ZBA Hearing RE: Law Boathouse on Lake Charlevoix

I write today particularly about the project's proposed covered angled walkway between the boathouse and the main residence, as pictured on the six pages of plans in the attached file, "Walkway Details.pdf" collected from the Laws' plans. I can see that these pages were prepared by different planners for the Laws on various dates, but what is common to all of them is the walkway. From scales on the drawings, the walkway is approximately 100 feet in length.

PROPOSED INLAND BOATHOUSE
 State/ Michigan County/ Charlevoix
 Township/ Hayes (T34N, R7W)
 Section/ 32 (10034 Anglers Cove)
 Body of water/ Lake Charlevoix
 Applicant/ Scott & Debra Law via
 Drost Landscape Company
 Date/ 07-02-2020
 Prepared by/ Great Lakes Ecosystems,
 Box 156, Indian River, MI 49749
 (c/o Bert C. Ebberts, 231-238-7615)

COVERED WALK TO HOUSE

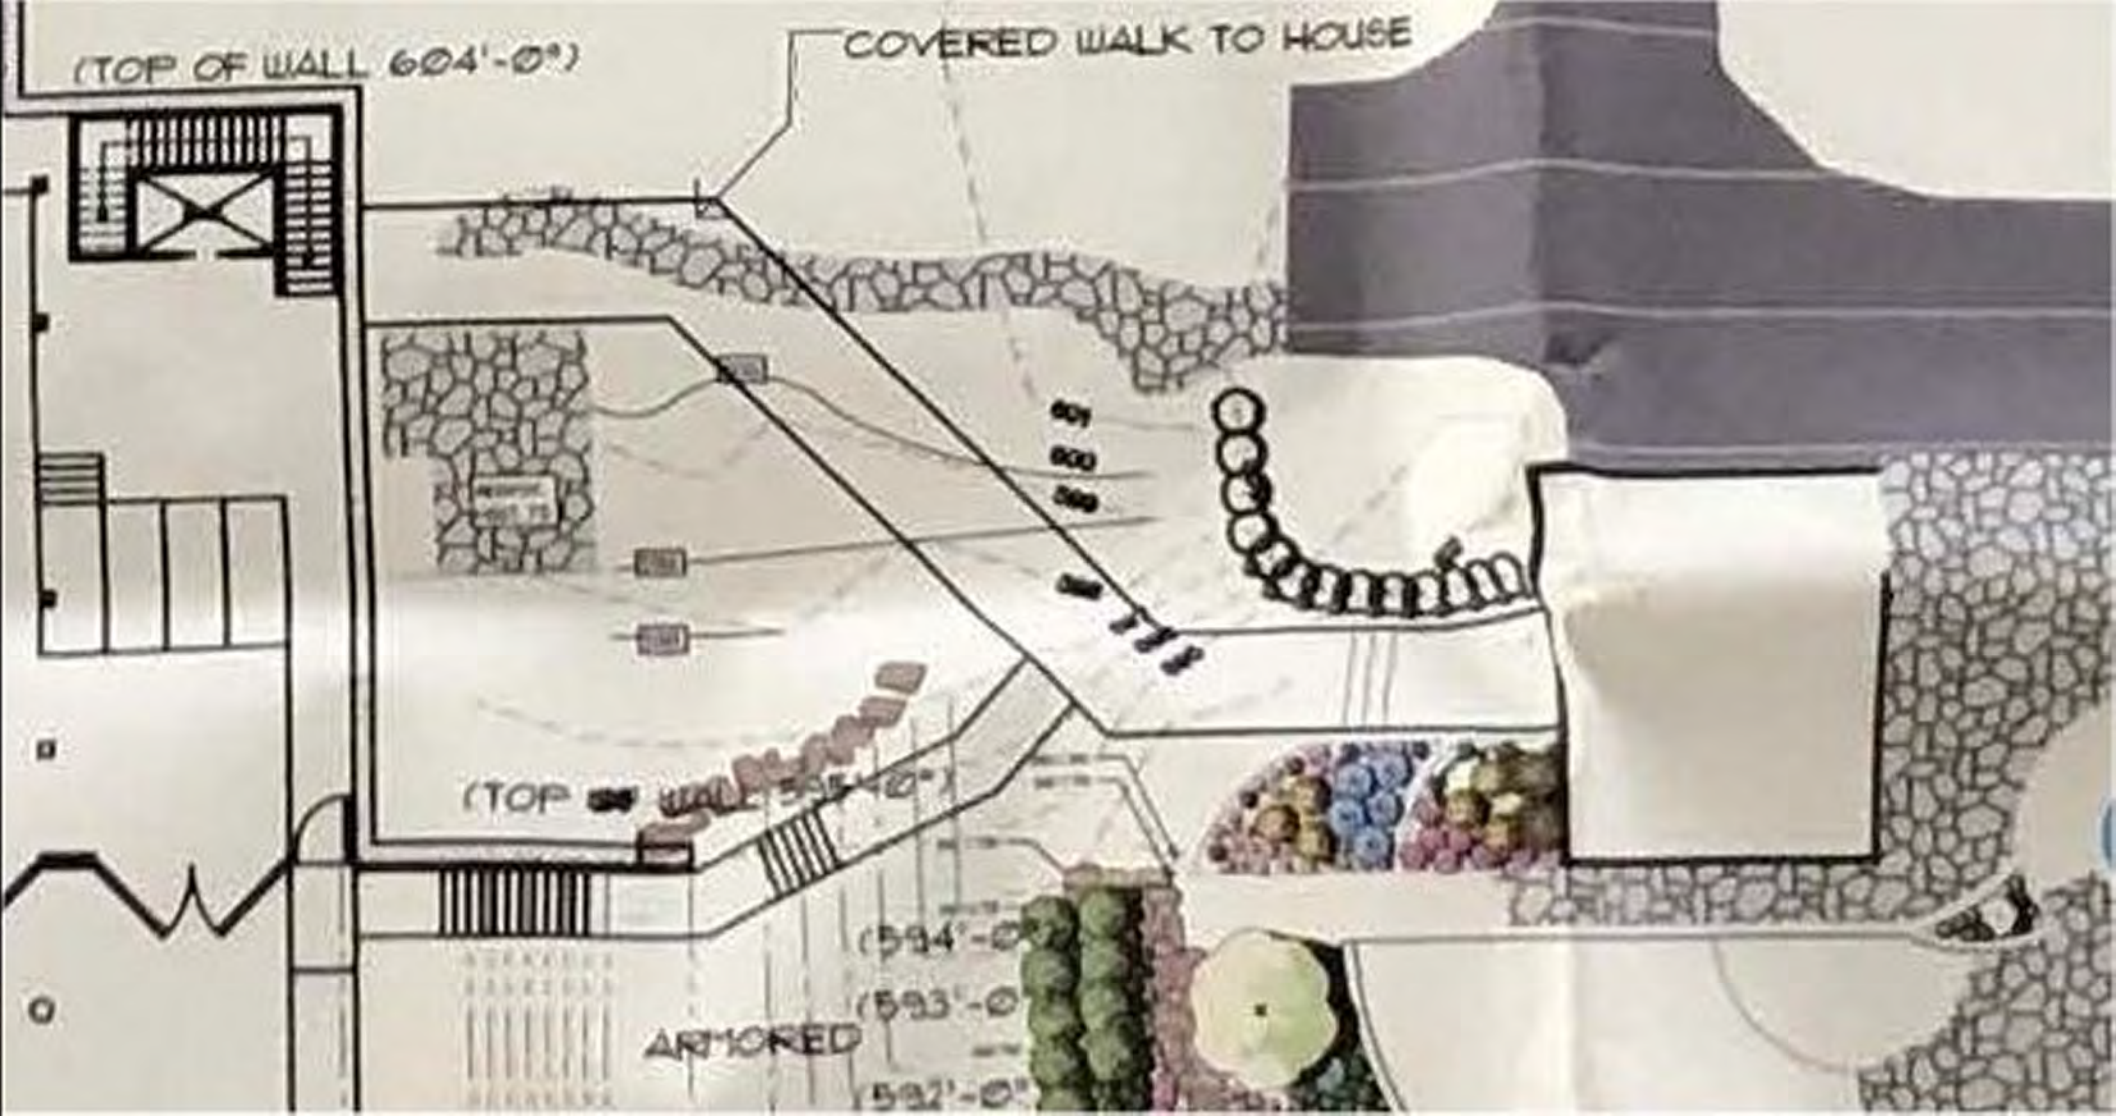
I do not believe that other builders or architects looking at the attached plans would consider the boathouse as "part of" the main residence, due to the proposed 100' covered walkway/breezeway. In my experience, a detached boathouse structure is "customarily incidental and subordinate to the use of a residence". In this case, the Law's

boathouse, as shown on attached plans, should be considered a separate structure and evaluated as an Accessory Building or Structure in the Township Zoning Ordinance.

I agree with the Zoning Administrator's affidavit that the Law Boathouse should be connected to the house to be considered a part of the main building. However, in this case the proposed 100' covered walkway/breezeway does not keep to the spirit of the Township Zoning Ordinance or the Zoning Administrator's affidavit. I believe others in the design and construction community would agree. Accordingly, I support the appeal as it concerns the boathouse.
